Regulation No. XXX

Uniform provisions concerning the approval of vehicles of category L with regard to specific requirements for the electric power train

Figure 1  
 Jointed test finger

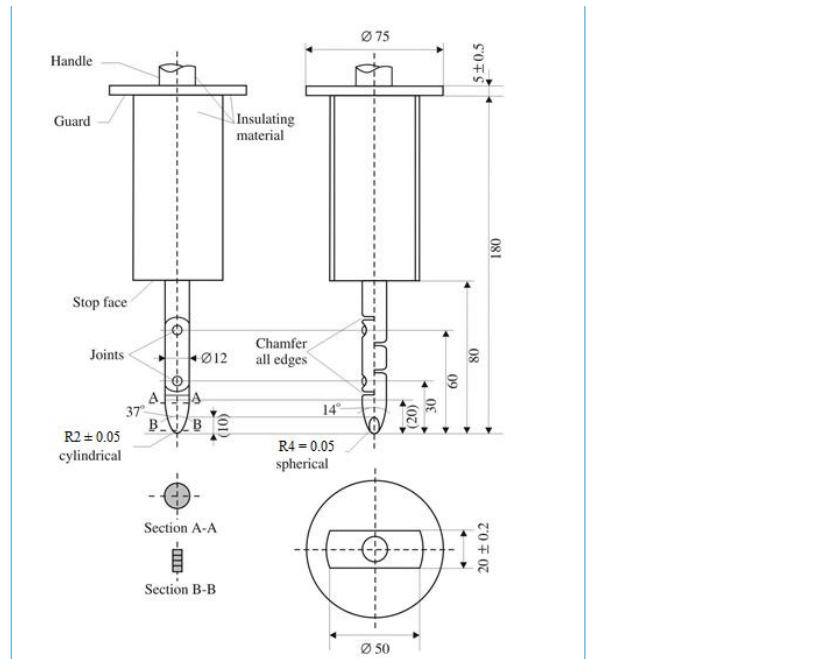
Kommentiert [MI 2]:  
 Toyota:  
 Error in the dimension.  
 Wrong R4 = 0.05 spherical  
 Correct R4 ±0.05 spherical
